### 1.1 Kerry County Council Response to Questions

Table 1.1 - Kerry County Council Response to Questions

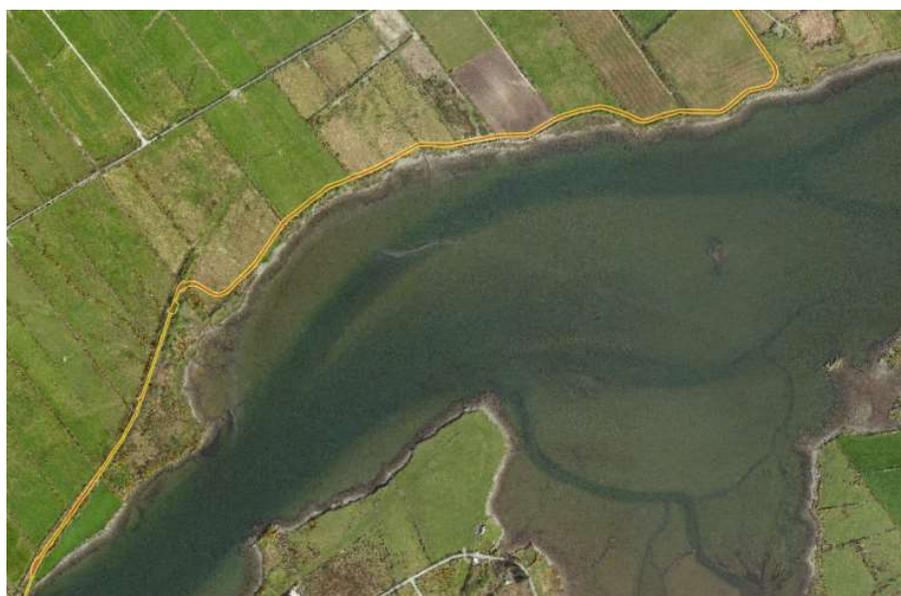
Ref.	Question	Response
1.	<p>What is the setback of the saltmarsh from the project and from the permanent fence line or 5.0m wide greenway corridor?</p>	<p>The setback of the 5m greenway from the saltmarsh (CM2 on the attached Drawing below) to the north along this section of the greenway ranges from 3m to 6m from the verge and 4m to 7 m from the pavement. Refer to extract from Appendix 11.3 Designated Site Maps and Habitat Maps below:</p>

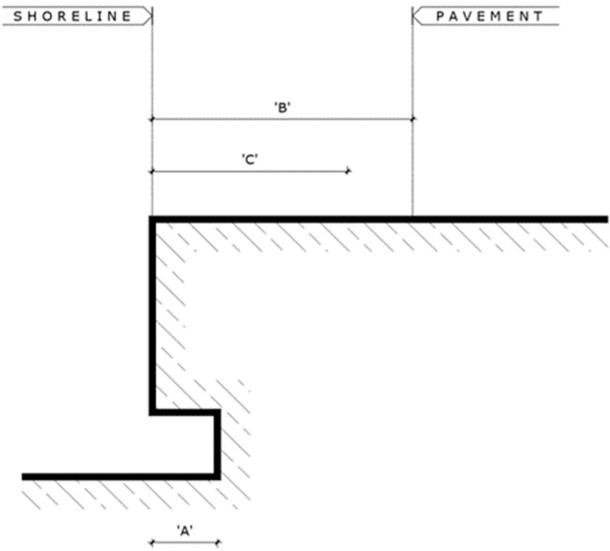
With regard to the influence of tidal flows on erosion rates we highlight the following:

In estuaries, tidal flows move fastest in the deeper channels, the darker areas in the aerial photo shown above. Flow in shallower areas will radiate out from the channel flow at a lower velocity than the tidal stream in the channels. Tidal flow is strongest at mid tide. The coastline in Cloghanelinaghan is above the high tide mark and set back 40m from the closest tidal channel therefore subject to radial tidal flow and thus will not have a significant impact on erosion rates.
